Garvin Design Group
1209 Lincoln St.
Columbia, SC 29201

ADDENDUM NO. 2

PROJECT TITLE
COLISEUM RENOVATE ROOMS 411 & 415
 Carolina Coliseum
 650 Park Street
 Columbia, SC 29201

1 REFLECTED CEILING PLAN - REVISED
 SK-A-1 1/2" = 1'-0" REFERENCED ON: A3.1

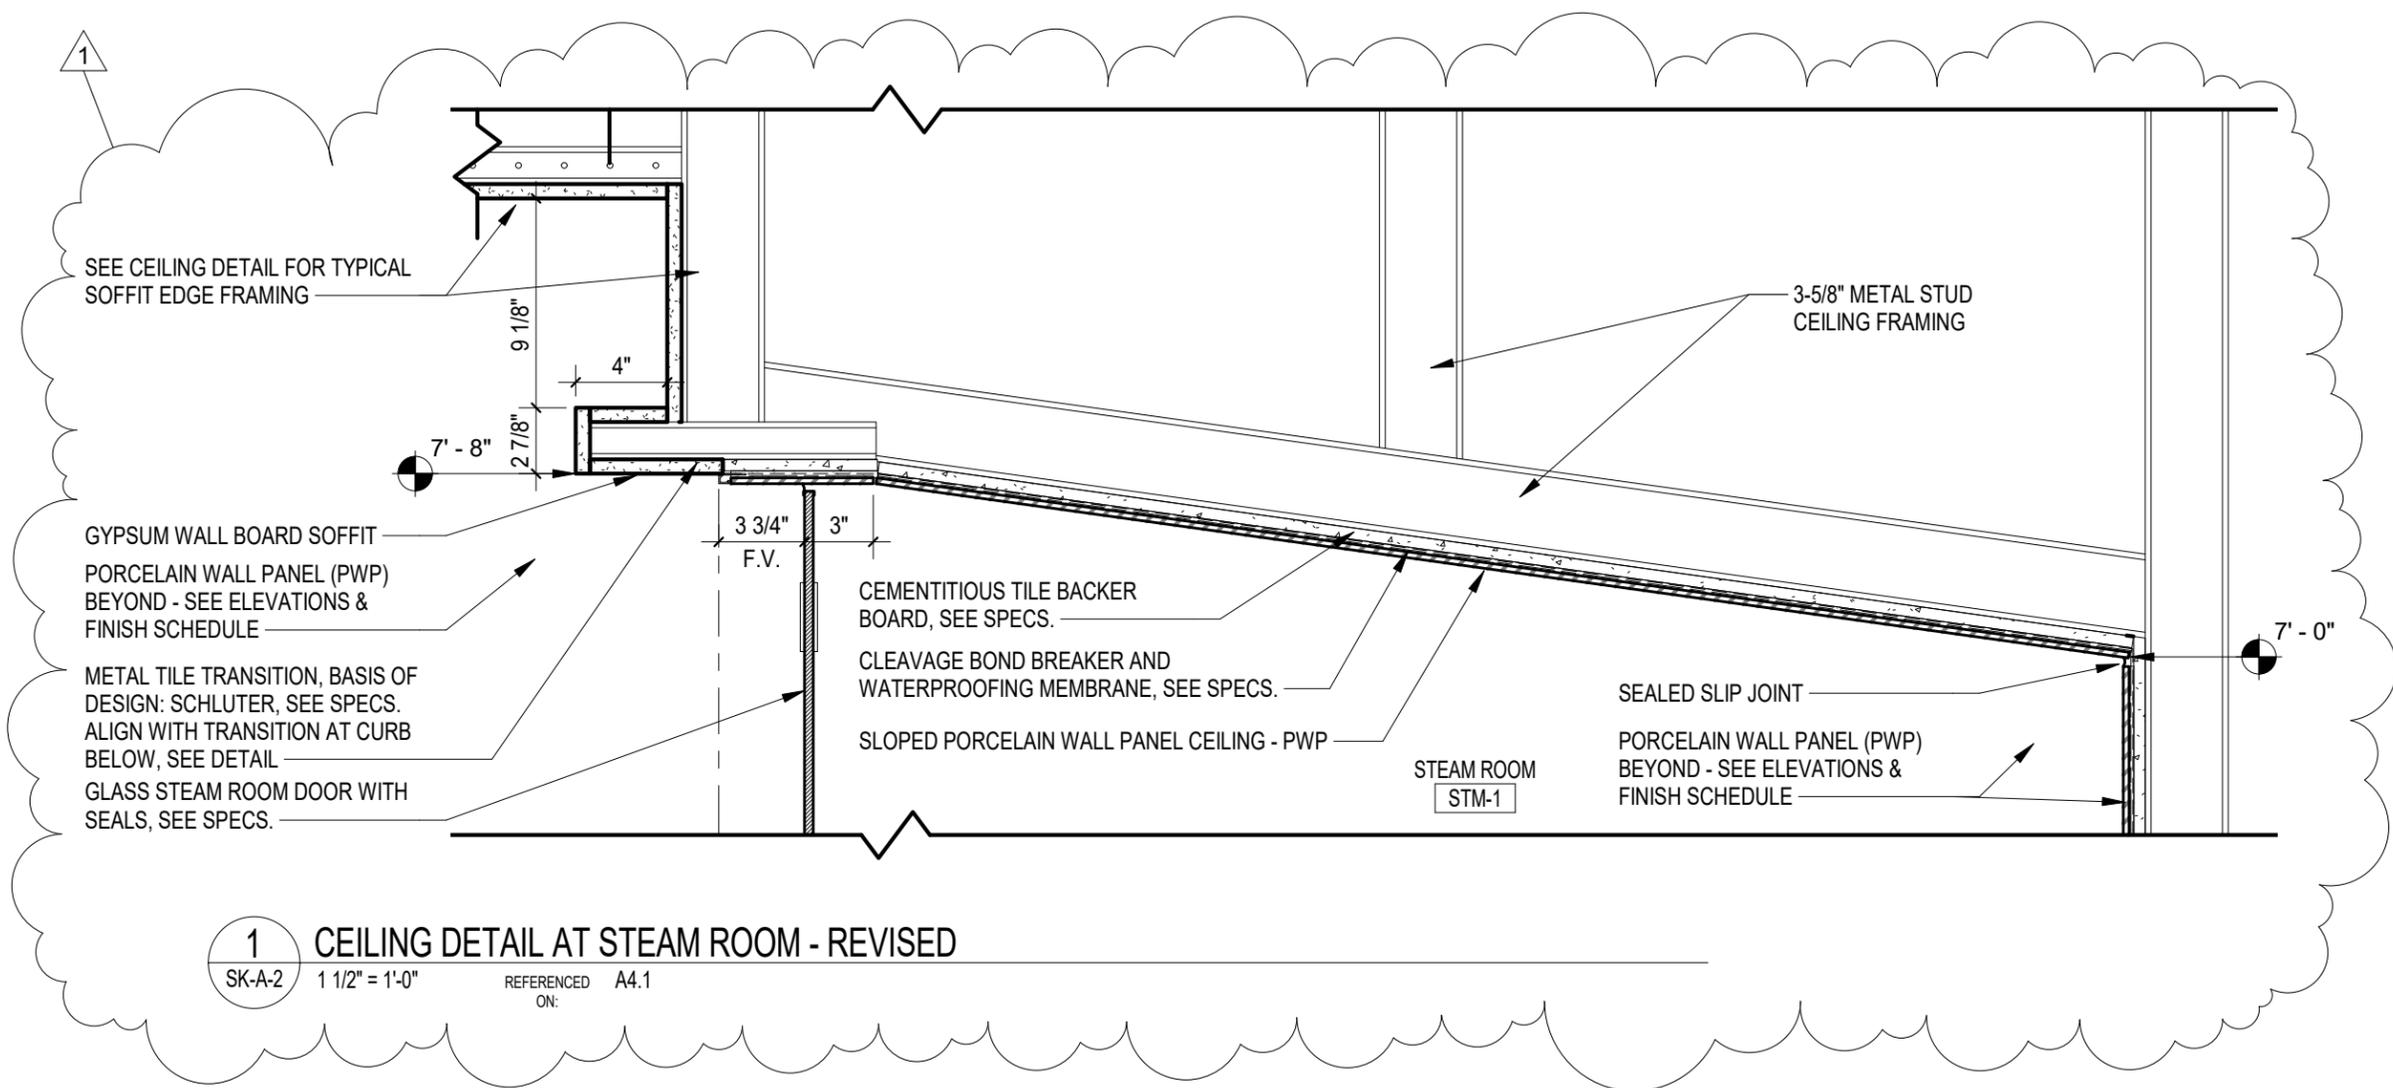
2. Reference Drawings 2/A1.1, 1/A2.1, 1/A3.1, 1&8/A4.1, 1/A5.1, and Finish Schedule. See also attached SK-A-1 THRU 4 for Clarifications for tile installation and details at Steam Room STM-1:

1. Where CTB-1 and PWP-1 occur, PWP-1 is intended to be installed directly above the base units.
 2. See Finish Plan notes for extents of PWP-1, essential wrapping shower enclosures, and stopping at outside corner with Schluter metal edge trim. Other North walls are painted, as scheduled. See note at Elevation 1/A4.1, “Note these walls are cut in section.”

1 CEILING DETAIL AT STEAM ROOM - REVISED
 SK-A-2 1 1/2" = 1'-0" REFERENCED ON: A4.1

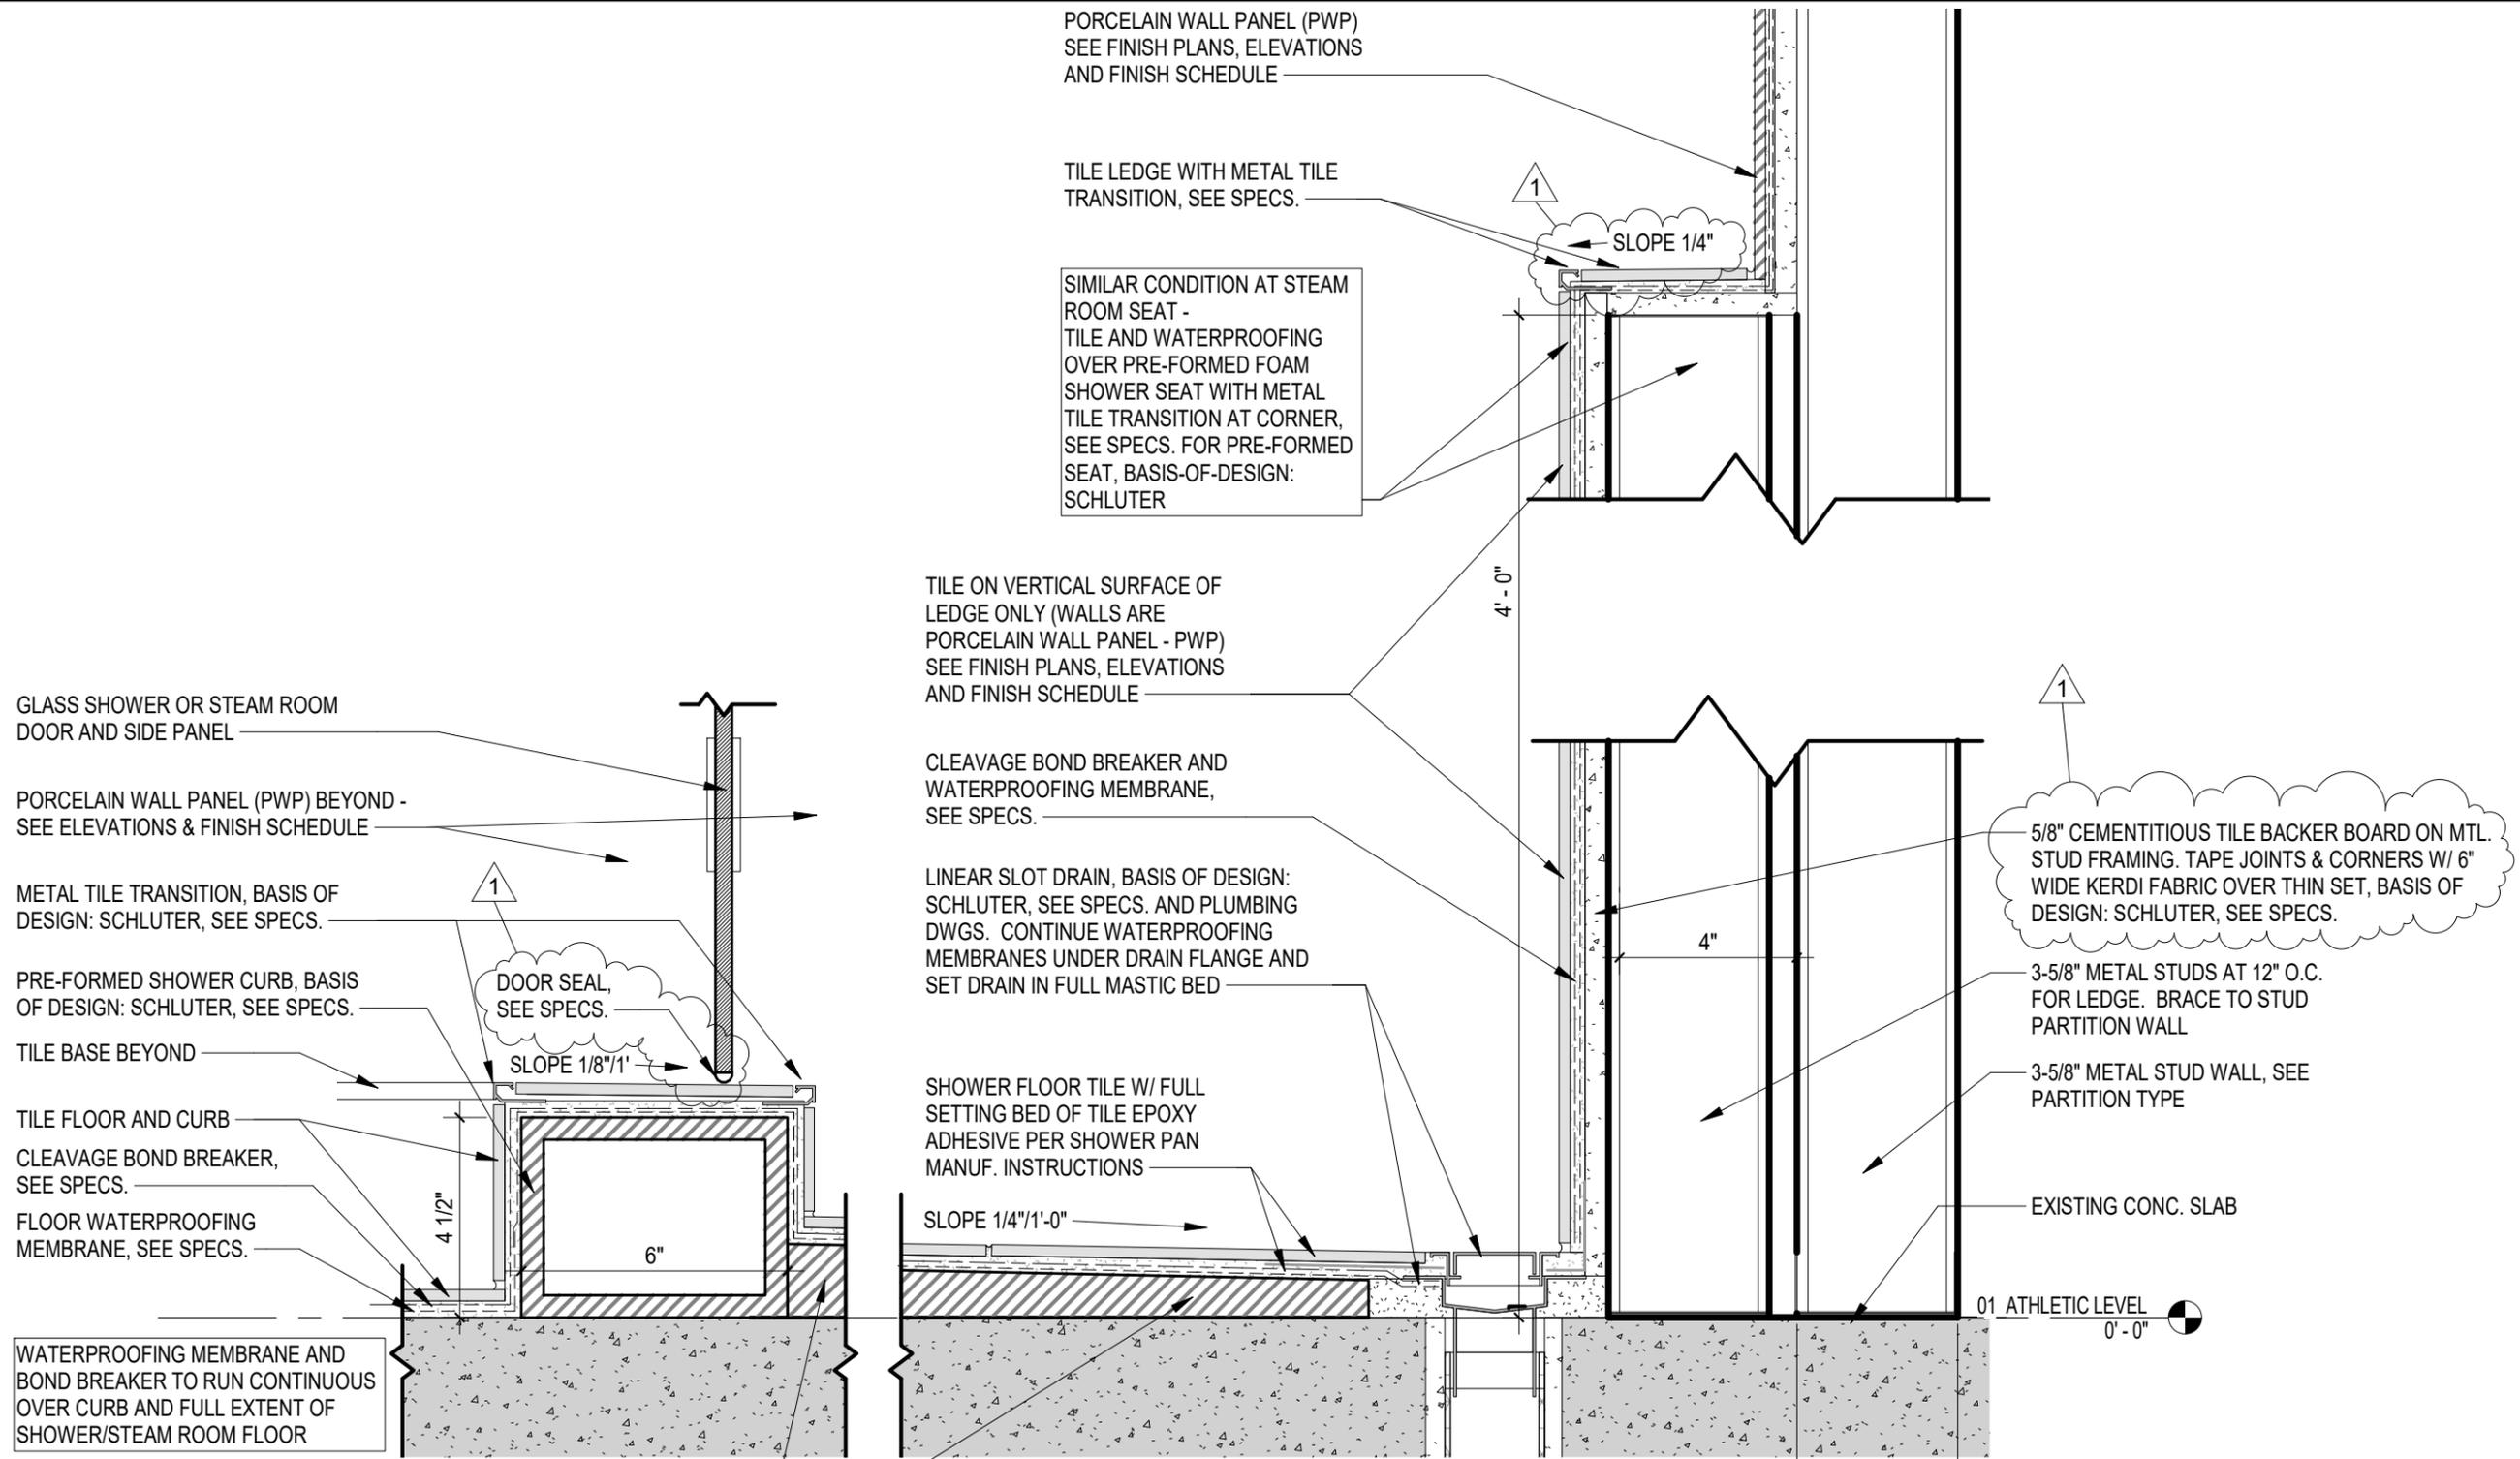
3. Direction of PWP is intended to run w long axis of panel vertical.
 4. Steam Shower Ceiling should be built in compliance with TCNA Detail SR614-18, including water-barrier and cement backer board, with PWP-1 face. Waterproofing should be continuous from front of soffit, to drain at floor.

1 SHOWER PAN SECTION - REVISED
SK-A-3 3" = 1'-0" REFERENCED ON: A1.1

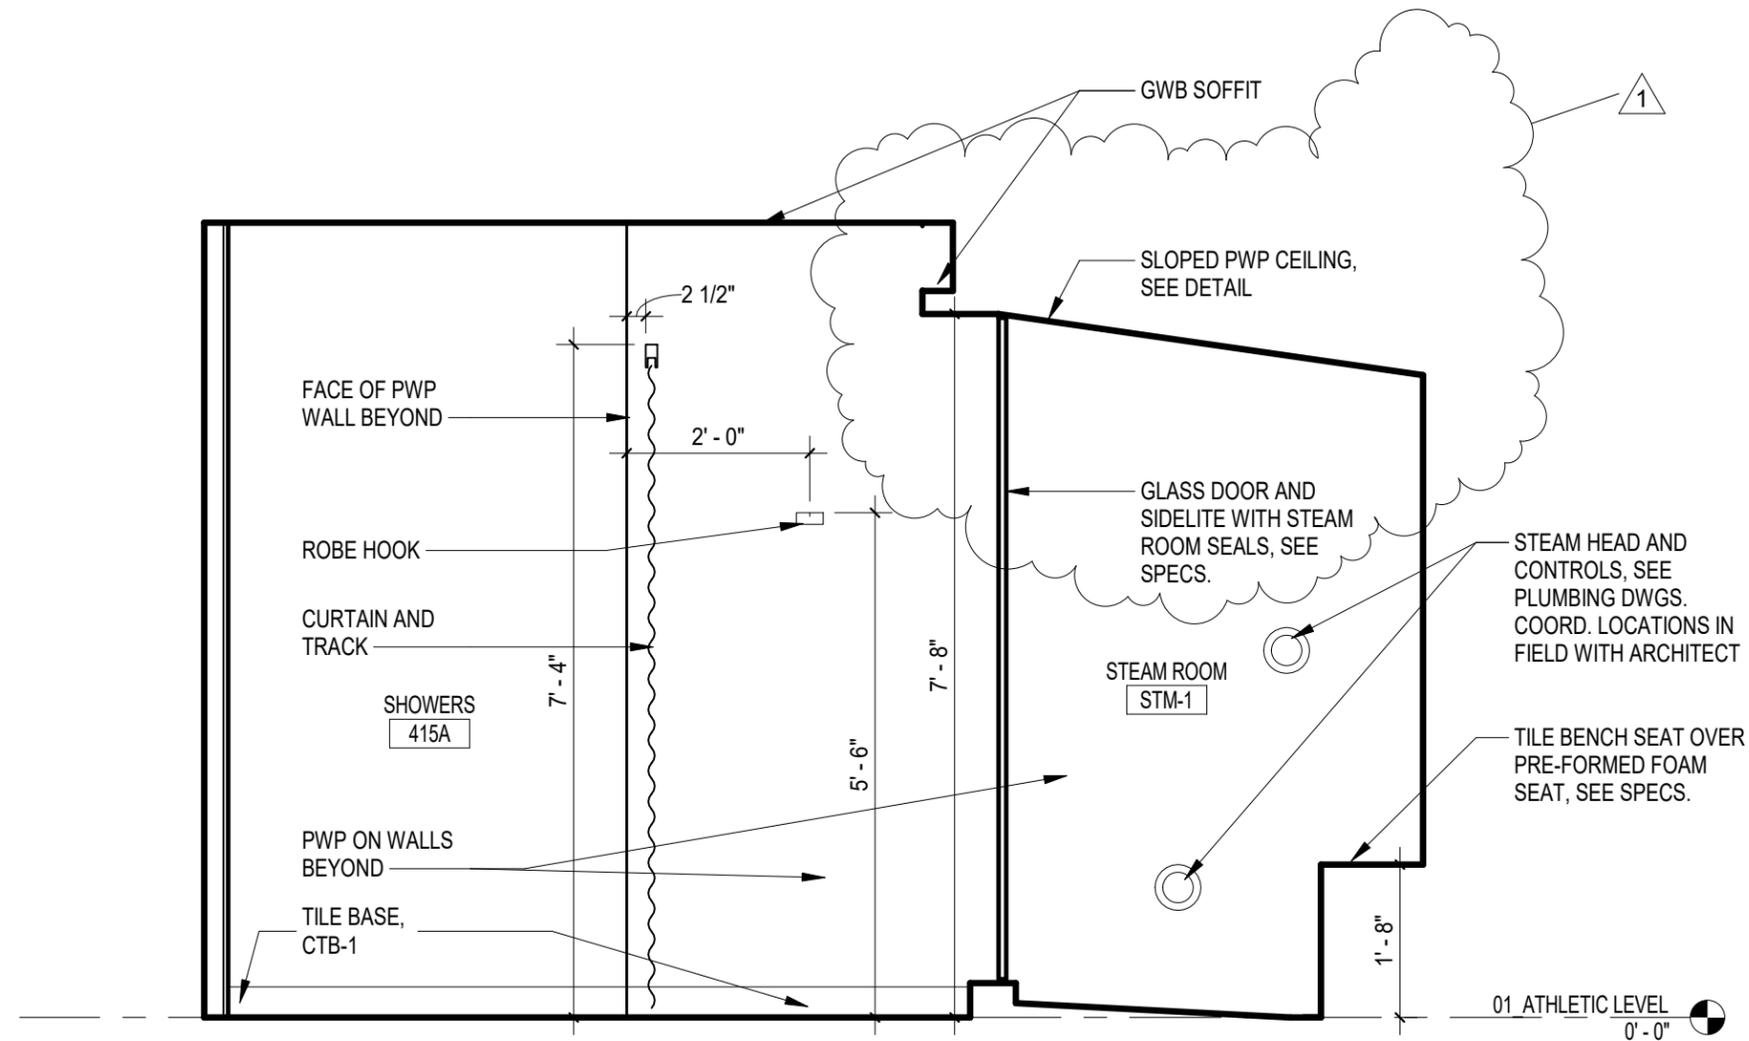
5. Per Detail 1/A3.1, Shower Ledge is constructed with stud framing and backer board; Shower Seat is constructed with structural foam, basis of design by Schluter.

PRE-FORMED SLOPED SHOWER
TRAY, BASIS OF DESIGN: SCHLUTER,
SEE SPECS.
